**TOWN OF BALLSTON PLANNING BOARD  
REGULAR MEETING MINUTES  
January 26, 2022  
via Zoom Only  
6:30 pm**

### ***60 Middleline Rd CSI (PB 2021-011)***

Site Plan Review and Special Use Permit for Community Solar Installation (CSI) - *Proposal of 5 MW AC CSI.*

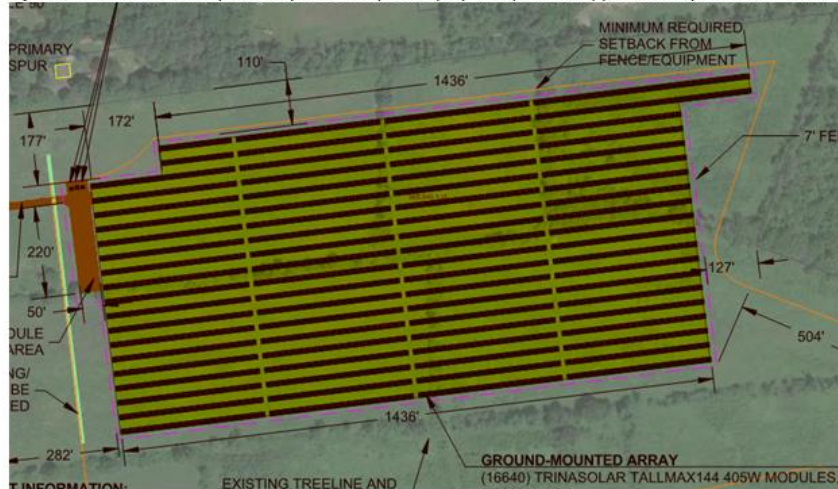
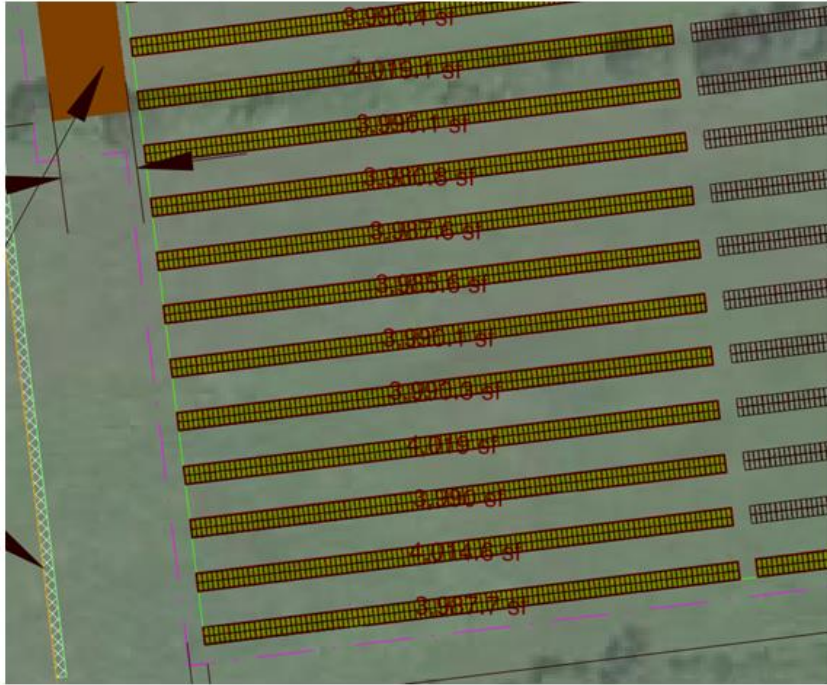
Ms. Lippmann stated that the zoning code is written as “system perimeter coverage”. Ms. Lippmann stated that she included the panel perimeter area but did not include the fencing perimeter. Ms. Lippmann stated that she had received Mr. Stickles’ interpretation that the coverage perimeter was the outside perimeter of the system as shown in the first figure below.

Ms. Lippmann showed two figures on the screen to illustrate how the coverage is being interpreted. The first picture shows the perimeter of the system and she received concurrence from Mr. Stickles as to the interpretation of the code. The coverage calculated as shown is 35.3% and because of the way the code is written, this is the way it was intended.

**Option 1** – all area encompassed by the solar panels (in yellow): This is approximately 22.2 acres or 35.3% coverage (exceeds zoning max of 20%).

Ms. Lippmann stated that if the interpretation were to be taken a different way to include just the surface area of the panels, then Mr. Ruthmann’s project would be at 12% coverage and the requirement would be satisfied.

**Option 2** – Only the surface area of the panels is calculated (in yellow). This is approximately 7.35 acres or 11.7% coverage and meets zoning.

Ms. Lippmann stated that the path forward is an area variance if the application cannot be modified to reduce the coverage.
